B6 NSW Office of Environment and Heritage

This chapter addresses issues raised by the NSW Office of Environment and Heritage (OEH).

B7 Heritage Council of NSW

This chapter addresses issues raised by the Heritage Council of NSW.

Figure 9-6 Lower north–south screenline: comparison of two-way AM peak one hour volumes

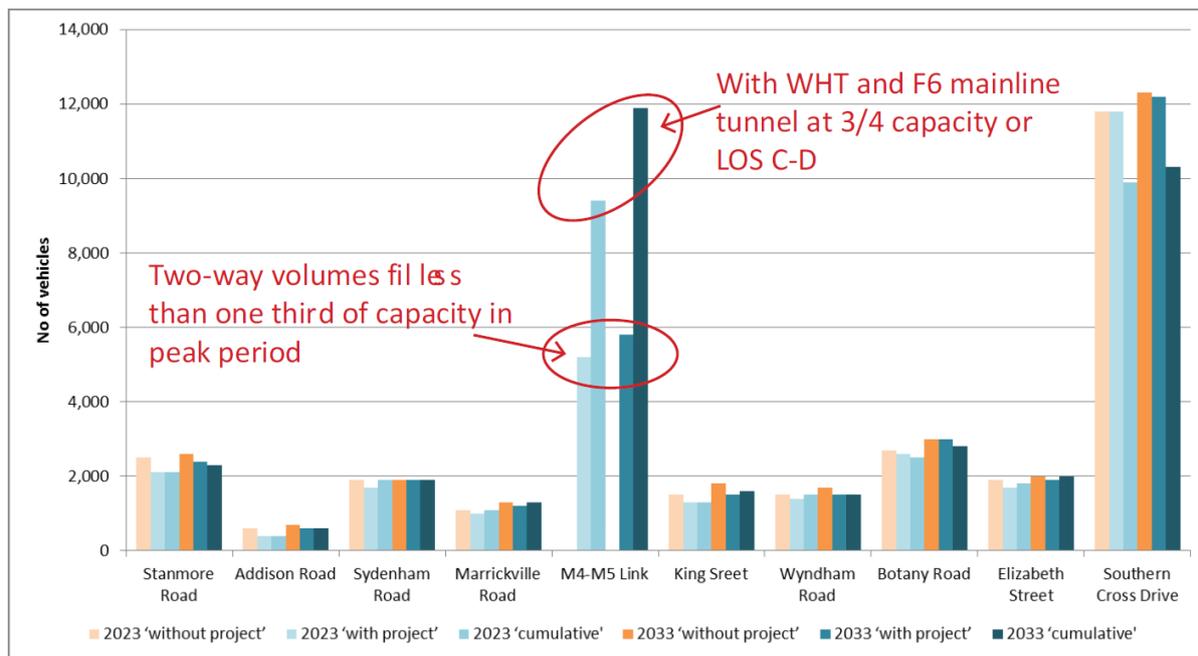
Hourly AM peak traffic volume estimates for the mainline tunnel (four lanes in each direction) indicate it would receive traffic volumes that are less than one third of the total capacity available. The hourly capacity for the proposed mainline tunnel of the M4-M5 Link is 16,000 vehicles/hour for both directions at Level of Service E, or 8,000 vehicles/hour in one direction. This is highlighted in Figure 4 [reproduced from Figure 9-6 as referenced below the figure].

Figure B10-3 Annual mean PM_{2.5} concentration at community receptors (with-project and cumulative scenarios) for 2023 and 2033

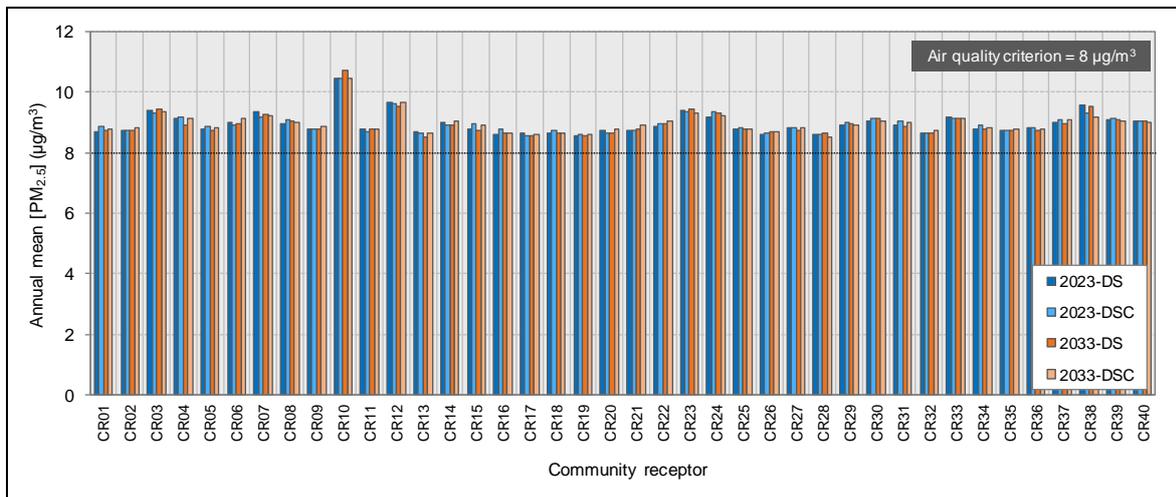
Before the EIS is determined the Proponent must publish a figure setting out the "annual mean PM_{2.5} concentration at community receptors (with-project (DS) and cumulative (DSC) scenarios, relative to corresponding Do Minimum scenarios)" in the same way it has been set out in Volume 1B, Figures 9-27, 9- 33, 9-39, 9-45.

The figure requested in City of Sydney's submission is included as Figure 8-71 in Appendix I (Technical working paper: Air quality) of the EIS and shown in **Figure B10-3** below. Figure 8-72 of Appendix I (Technical working paper: Air quality) of the EIS was erroneously added to Chapter 9 (Air quality) of the EIS (as Figure 9-51) instead of Figure 8-71. This error has been captured in the clarifications chapter of this report (see **Chapter A4** (Clarifications)).
